24 Redington Gardens London NW3 7RX Ref. 2019/3081/P

Delegated Report	Analysis sh	eet	Expiry Date: 29/08/2019				
(Members Briefing)	N/A / attache	N/A / attached		15/09/2019			
Officer		Application N	umber(s)				
Joshua Ogunleye		2019/3081/P					
Application Address	Drawing Numbers						
24 Redington Gardens London NW3 7RX		See draft decis	See draft decision notice				
PO 3/4 Area Tea	m Signature C&UD	Authorised Of	fficer Signature				
Proposal(s)							
Variation of condition 3 (approved plans) of planning permission 2016/1015/P dated 22/07/2016 (Demolition of existing dwelling house and the erection of a replacement dwelling house, including the excavation of the basement and associated hard and soft landscaping).							
Namely to increase size of the approved basement, installation of ASHP to rear, installation of rooflights within the front and rear garden area, installation of front elevation window at lower ground level and increase in size of the approved chimney.

Recommendation(s): Grant variation of condition subject to Section 106 legal agreement							
Application Type:	Variation of Condition (s.73)

Photo 7 (above): Implemented roof/chimney

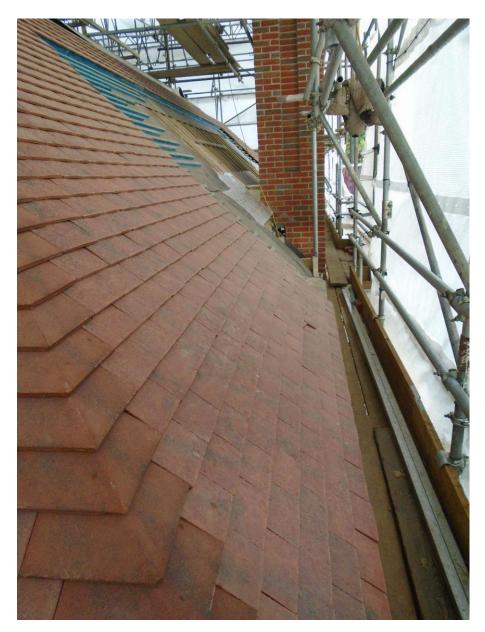
3.9The proposed chimney works would result in an overall length increase by extending its base to the ground level. This is in order to increase the chimney's service use. The proposed works would not result in a height increase to the chimney breast. Where the proposed chimney would be visible from the public realm officers consider its design and appearance to be acceptable.
